1415 W 10th Street Residence

HLC PRESENTATION | CLARK RICHARDSON ARCHITECTS | 7.09.2021

Responses to Preservation Staff Comments at the Previous HLC Meeting:

Proposed Project: Site Plan

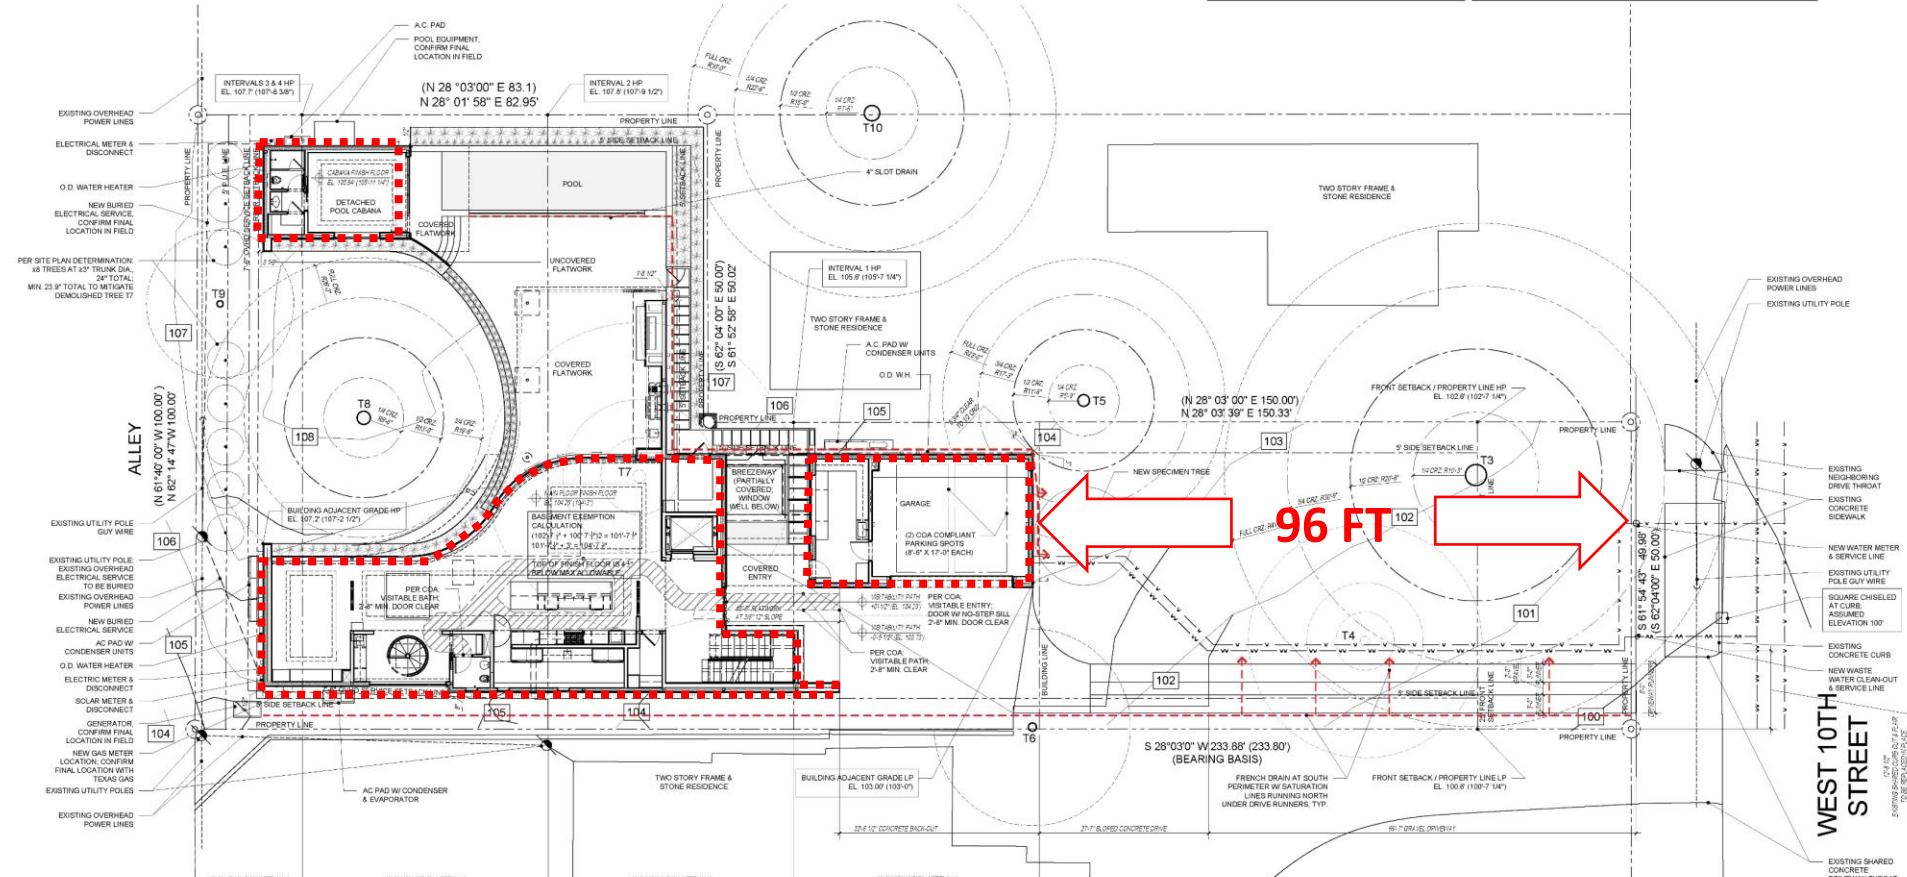
Staff Comments: Consider referral to the Architectural Review Committee. Otherwise, comment on and release the plans, encouraging the applicant to relocate the garage to the rear of the main building, omit the painted steel accents, and reduce the roofline's complexity.

Garage: The owner prefers access to the property from W 10th street and not the alley – frankly, this is more neighborly too. We intentionally disconnected the garage from the house so entry to the house at the front door was visible from the street. It is not feasible to relocate the garage to the rear of the main building given the other restrictions including:

- Rear Electrical Easement
- Protected Post Oak Heritage Tree to the rear.
